# Service Bulletin

Ref. No. **COM-0218 (B056)**

<b>Subject</b>	<b>Note when releasing the paper jam/maintaining the machine (Prohibition of use of the flammable sprays and liquids)</b>
<b>Model</b>	All models

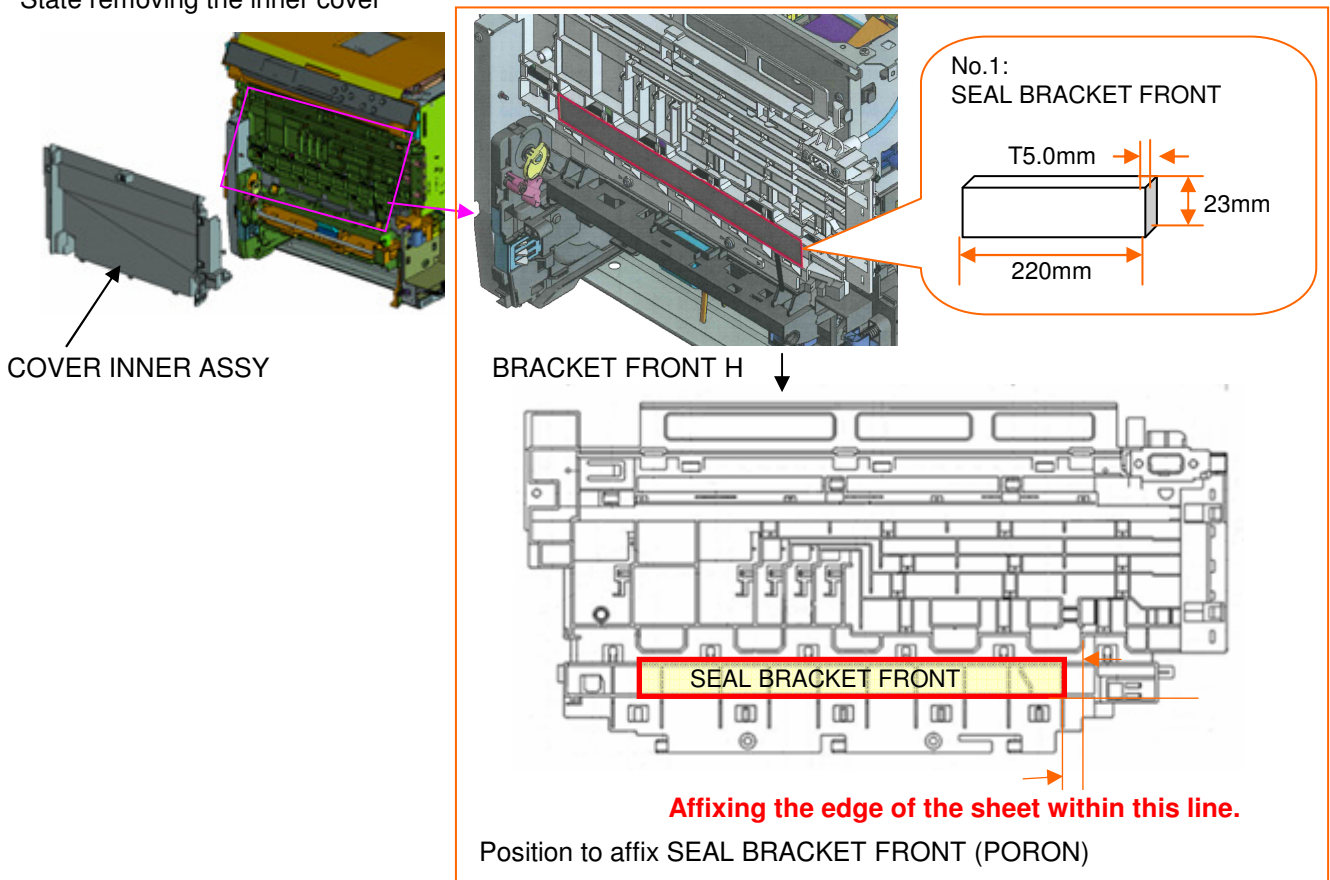
For improving the abnormal noise due to vibration that occurs when driving the main machine, the PRON sheet (No.1) for reducing vibration is affixed on the mounting plate (BRACKET FRONT HV) at the inner cover (COVER INNER ASSY) backside.

\* Part to affix PORON sheet  
State removing the inner cover

**<Change of REAR COVER**

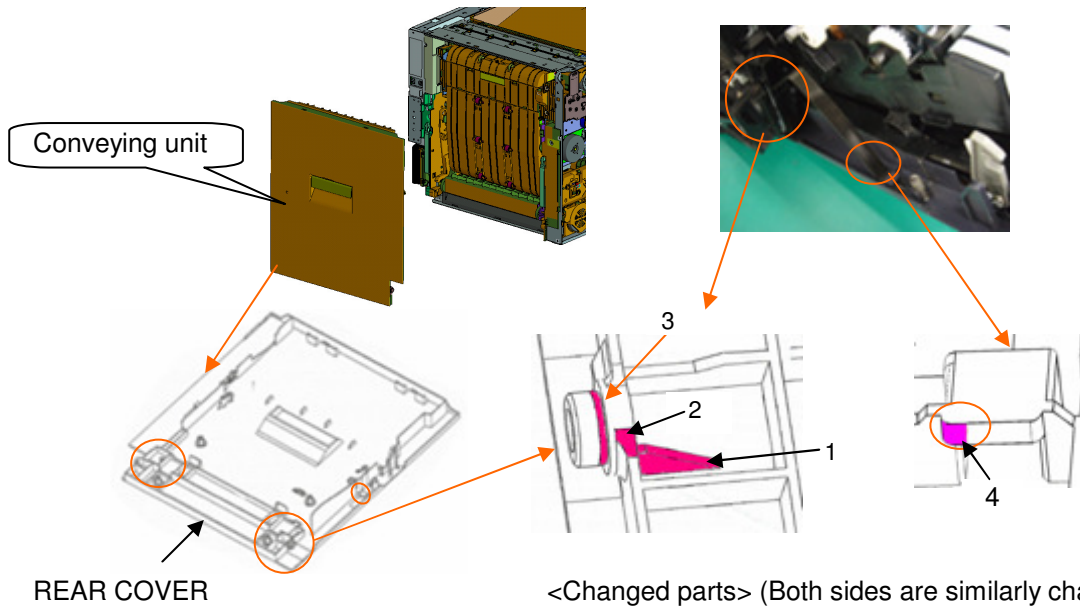
Thickness is added to 1, 2, 3 and 4 in encircled parts of REAR COVER.

**<Parts number information**

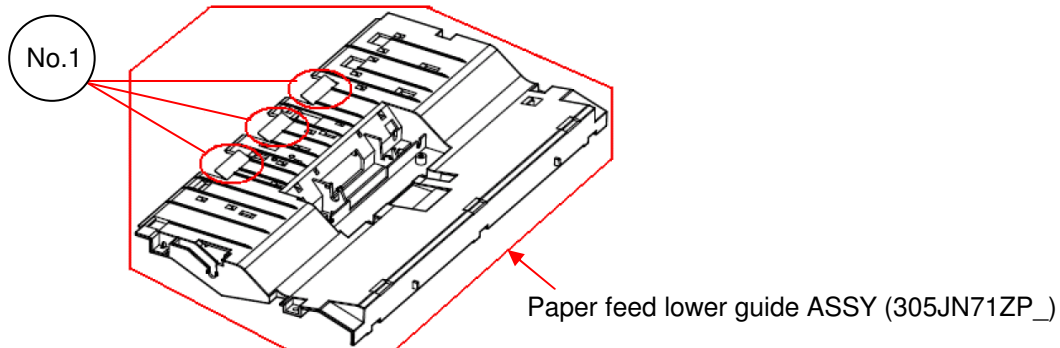
The parts number of the sheet (No.1) is set that is affixed to the paper feed lower guide at RADF section by 3 pcs. Paper feed lower guide ASSY (305JN71ZP\_) that affixes the sheet (No.1) has been supplied before setting this parts number.

**<Common use of the parts (Secondary transfer guide)>**

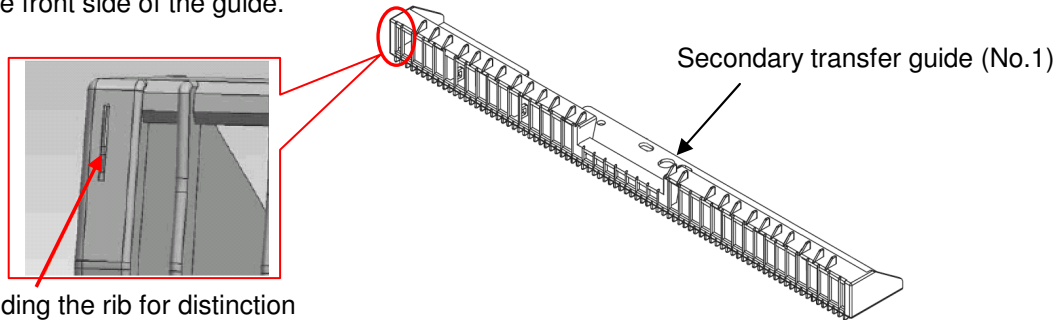
The rib on the secondary transfer guide (No.1) is thickened for common use of the parts. The parts number remains unchanged according to this change. However, the rib for distinction is added to the machine front side of the guide.

**<Change of the power cord caution label --> After using up the old stock>**

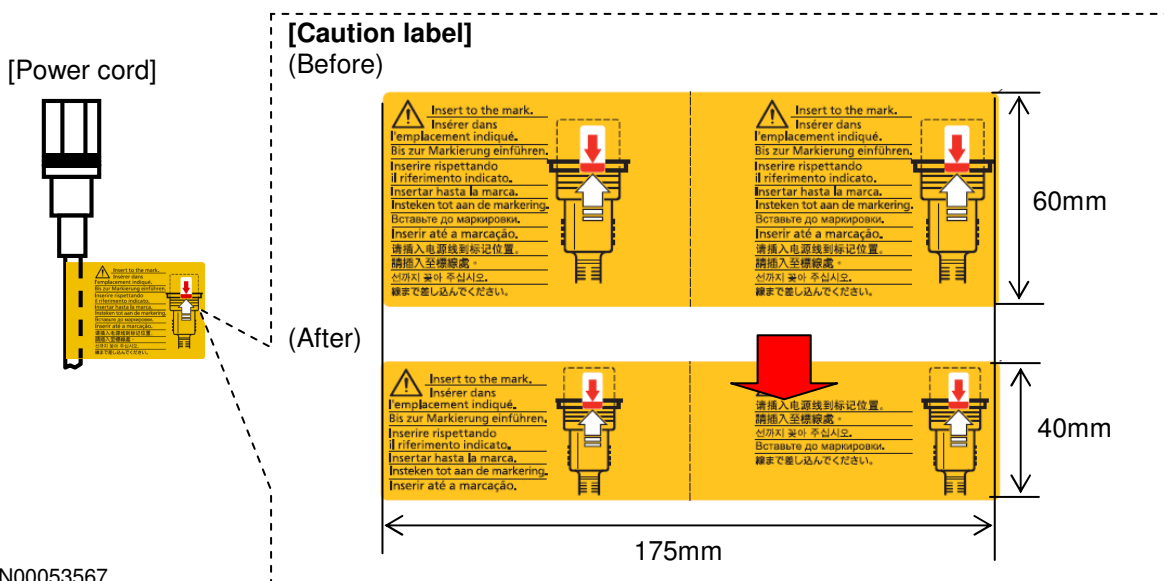
For improving the assembly process, the caution label affixed to the power cord is changed as below. The parts number remains unchanged according to this change.

- 1) Change of the size. (Height: 60mm --> 40mm)
- 2) Relocation of the caution contents according to the above change. (Contents remain unchanged.)

## <Revision of Toner Installation Guide --> After using up the old stock >

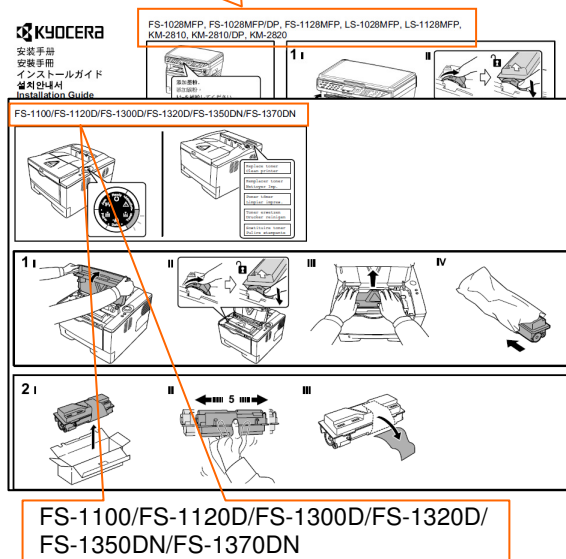
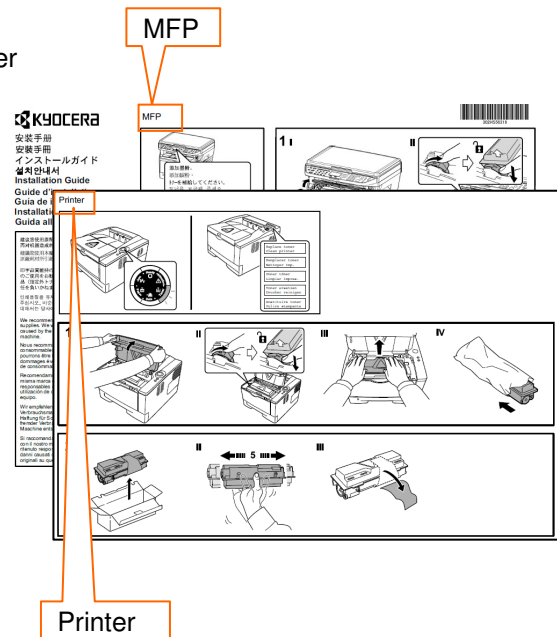
Toner Installation Guide is revised for common use of the guide with the new models.

**<Content of changes>**

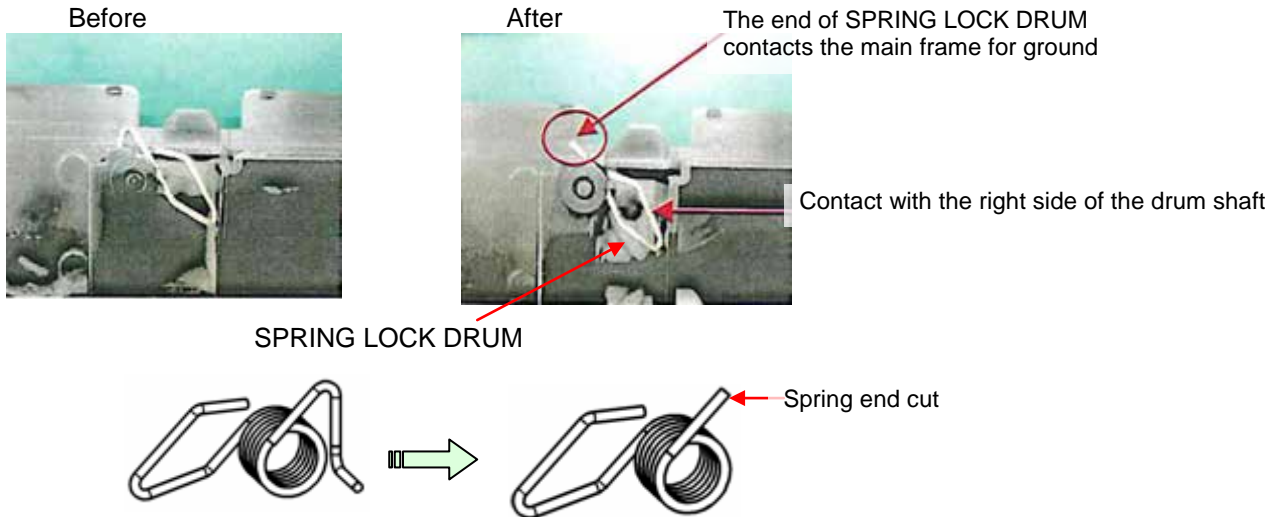
The shape of the drum lock spring (SPRING LOCK DRUM) is changed.

## 2. SC4600 error (LSU cleaning motor error)

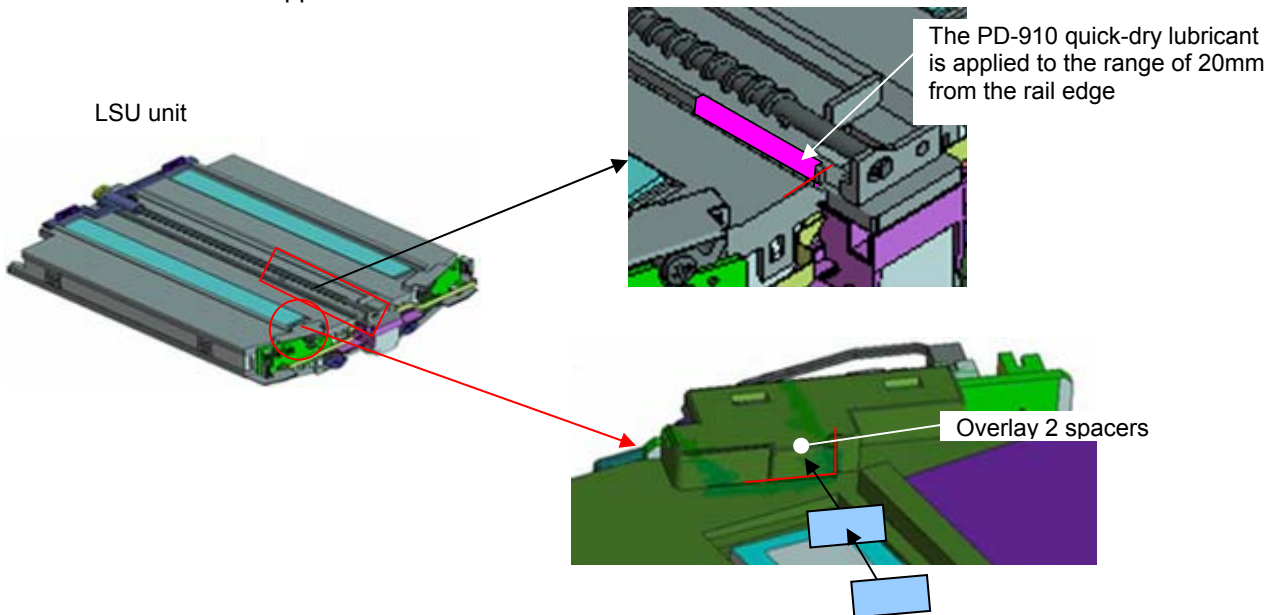
The motion failure may occur if the cleaning holder tilts when the LSU cleaner move. Therefore, a spacer is added and lubricant is applied to the rail.

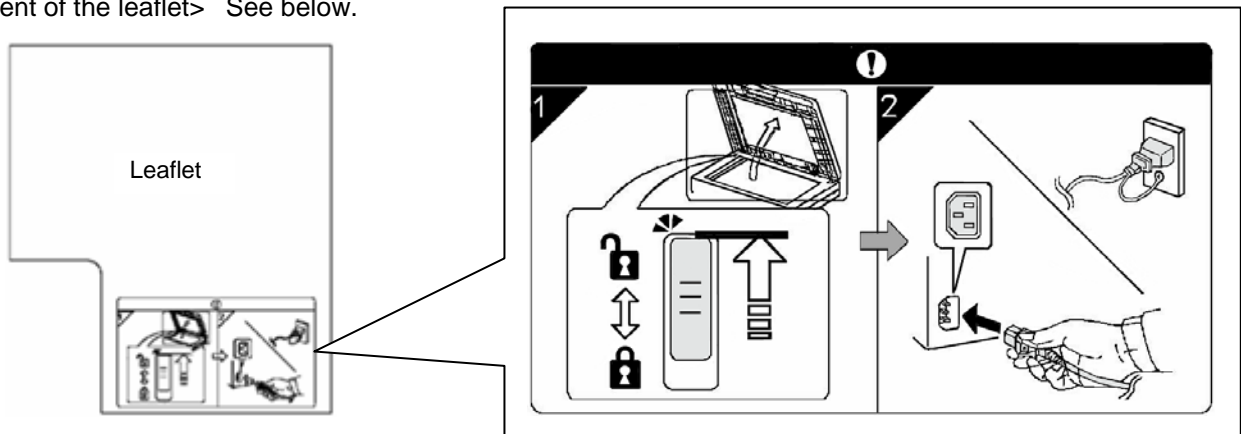
The lock lever locks the ISU for transportation. If omitting to release the lock lever, the C3100 error (ISU home position error) occurs when the power is turned on at the machine set-up. Therefore, a leaflet to instruct releasing the lock lever is added.

## <Content of change>

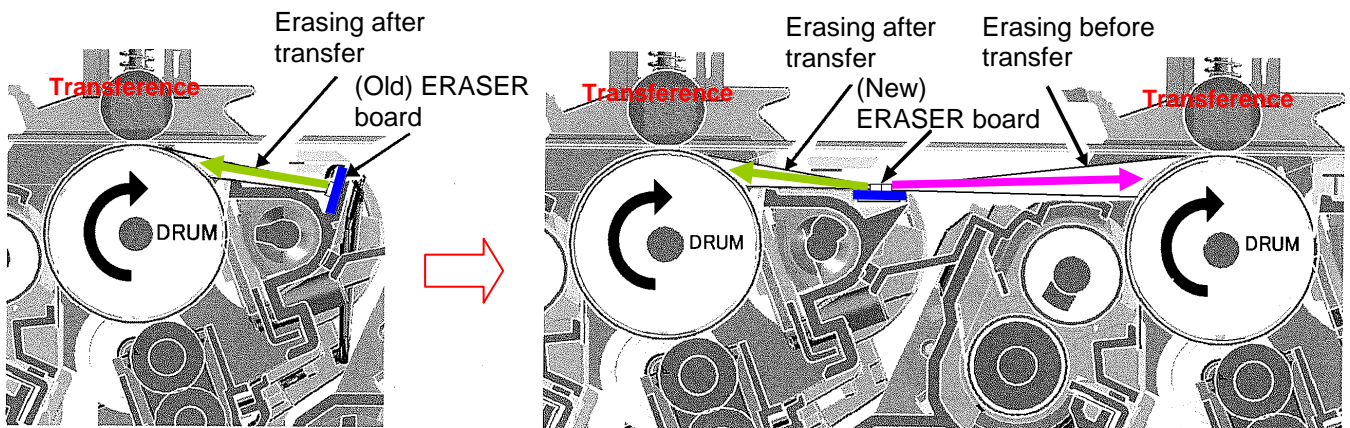
As a measure against ghost images in the field, the drum unit is changed as follows.

<b>Subject</b>	<b>Change of LEVER INTERLOCK (Corrective measure for the display failure of REAR COVER opening).</b>
<b>Model</b>	<b>FS-C5150DN, FS-C5250DN, FS-C2026MFP, FS-C2126MFP, FS-C2026MFP+, FS-C2126MFP+, FS-C2526MFP, FS-C2626MFP</b>

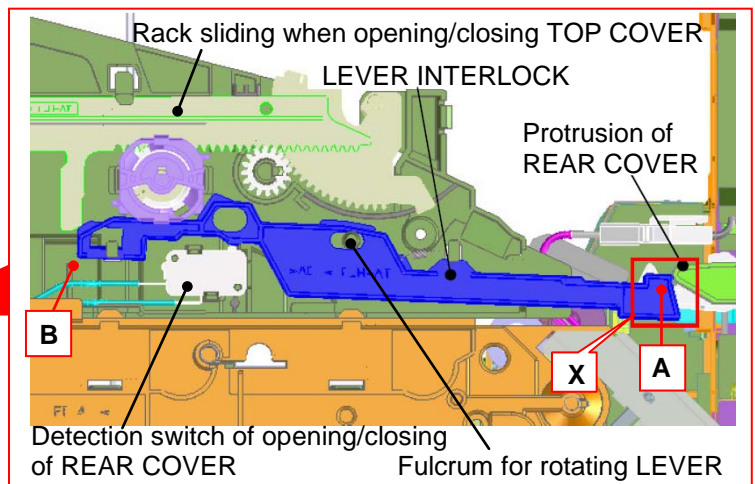
In rare case, the message "The cover is opened" is displayed by misdetection of REAR COVER opening when slowly closing TOP COVER while REAR COVER is closed. Thus, the shape of LEVER INTERLOCK is partly changed for improving its motion for switching the detection switch of REAR COVER opening/closing.

**[Permanent measures]**

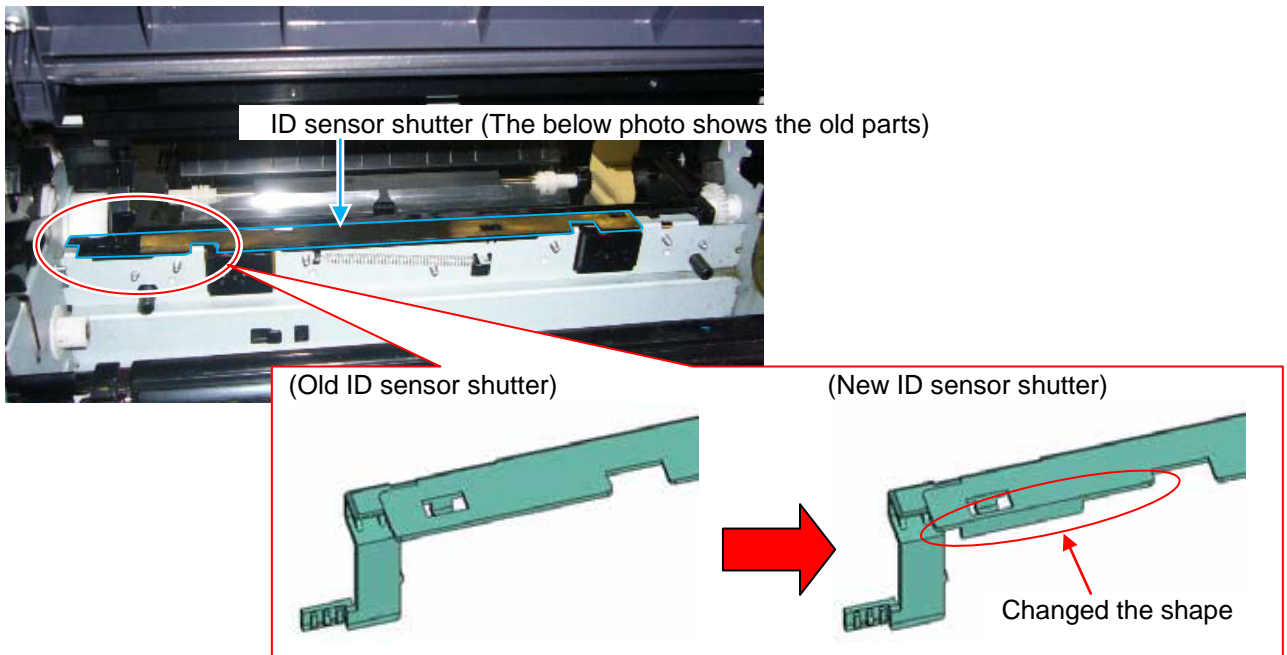
The shape of the ID sensor shutter contacting the Bk drum unit is cut to prevent the ID sensor shutter from coming off. (It will be implemented after using up the old stock)
